UNITED STATES PATENT AND TRADEMARK OFFICE

APPLICATION NO.	FILING DATE	FIRST NAMED INVENTOR	ATTORNEY DOCKET NO.	CONFIRMATION NO.
10/771,287	02/05/2004	Tomomi Endo	03327.2319	1144
7590	08/10/2004			
Finnegan, Henderson, Farabow, Garrett & Dunner, L.L.P. 1300 I Street, N.W. Washington, DC 20005-3315			EXAMINER LE, THANH TAM T	
			ART UNIT 2839	PAPER NUMBER

<p align="center">Office Action Summary</p>	<p>Application No.</p> <p>10/771,287</p>	<p>Applicant(s)</p> <p>ENDO ET AL.</p>	
	<p>Examiner</p> <p>Thanh-Tam T. Le</p>	<p>Art Unit</p> <p>2839</p>

DETAILED ACTION

Fig. 4

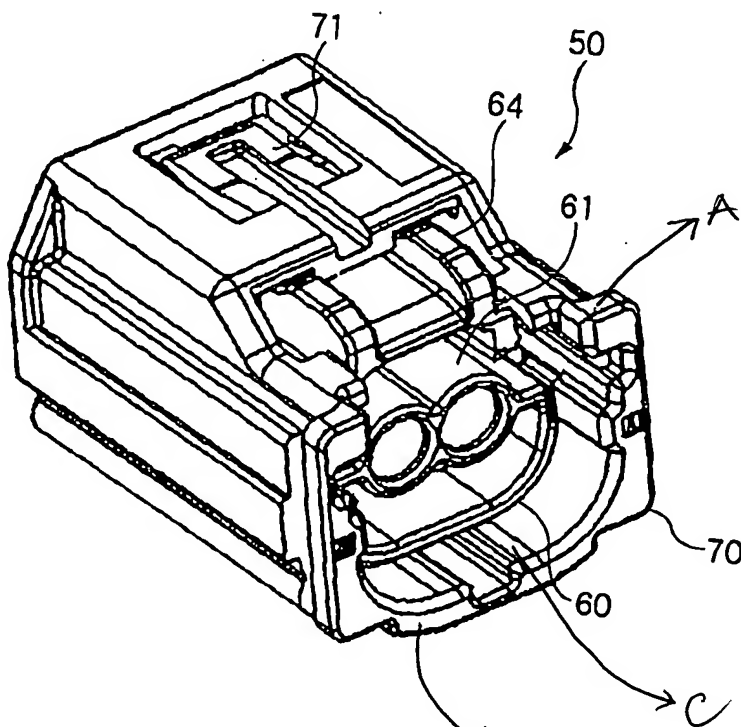
3. Figures 4 and 5 should be designated by a legend such as --Prior Art-- because only that which is old is illustrated. See MPEP § 608.02(g). Corrected drawings in compliance with 37 CFR 1.121(d) are required in reply to the Office action to avoid abandonment of the application. The replacement sheet(s) should be labeled "Replacement Sheet" in the page header (as per 37 CFR 1.121(d)) so as not to obstruct any portion of the drawing figures. If the changes are not accepted by the examiner, the applicant will be notified and informed of any required corrective action in the next Office action. The objection to the drawings will not be held in abeyance.

6. Claims 1-5 are rejected under 35 U.S.C. 102(b) as being anticipated by Applicant's prior art (figures 4 and 5).

Applicant's prior art, figures 4 and 5, discloses a connector comprising:

- a first connector housing (60) provided with a flexible lock arm (64);
- a tubular fitting detector (70) fitted to an outer periphery of the first connector housing while being slidable thereon between a first position and a second position;

- a retainer (71) provided on the fitting detector, and adapted to be engaged with a first position of the lock arm in a case where the fitting detector is placed at the first position, and engaged with a second position of the lock arm in a case where the fitting detector is placed at the second position;

- a second connector housing provided with a projection adapted to release the engagement between the retainer and the first position of the lock arm in a case where the second connector housing is completely fitted with the first connector housing, so that the fitting detector is allowed to slide from the first position to the second position; and

- a finger pad (A, see a figure below) provided on the fitting detector, and arranged such that an operator's finger is placeable thereon while being separated from at least the lock arm, during a fitting operation between the first connector housing and the second connector housing.

Regarding claim 2, an upper face of the finger pad on which the operator's finger is placed is situated upper than an upper face of the lock arm.

Regarding claim 3, the finger detector comprising a pair of side walls and a bridge member (B, see the figure below) connecting the side walls while preventing the operator's finger from being brought into contact with the first connector housing.

Regarding claim 4, the bridge member comprising a guide projection (C, see the figure below) which is usually brought into contact with the first connector housing.

Regarding claim 5, the guide projection is extended from the bridge member in a sliding direction of the fitting detector.
